Eskom	Tender Questions and Answers	Document Identifier	240-7124948	Rev	1
		Effective Date	01 April 2023		
		Review Date	April 2026

Request for Enquiry Number	WCTX1132FM
Description / Project Title	Procure, transport, delivery, and installation of 3 x mobile office units (Including ablution facilities for electricity, water, and sanitation) to Upington, Aurora and Gourikwa substations
Tender Questions Closing Date	21 September 2023

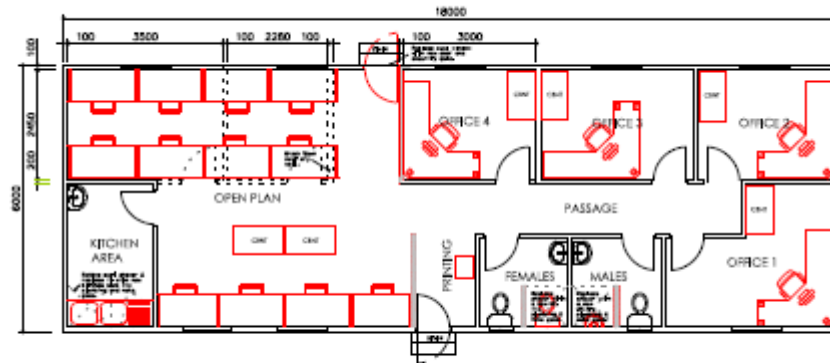
Item	Questions	Answers	Clarity Published Dates
1.	Site location for Aurora	Vredenburg town	14 September 2023
2.	Do you have a layout drawing	Please see attachment at bottom of page	14 September 2023
3.	Carpets – please clarify - bitumen carpet a. Placement of bitumen carpet b. Placement of laminated floor	a. carpet for office area b. Vinyl floor covering for kitchen and toilets	14 September 2023
4.	Paraplegic/disabled a. You requesting for paraplegic toilets but you have not allowed for a ramp	a. No paraplegic toilets required	14 September 2023
5.	Do you require a geyser / hydroboil in the kitchen	Hydroboil in the kitchen	14 September 2023
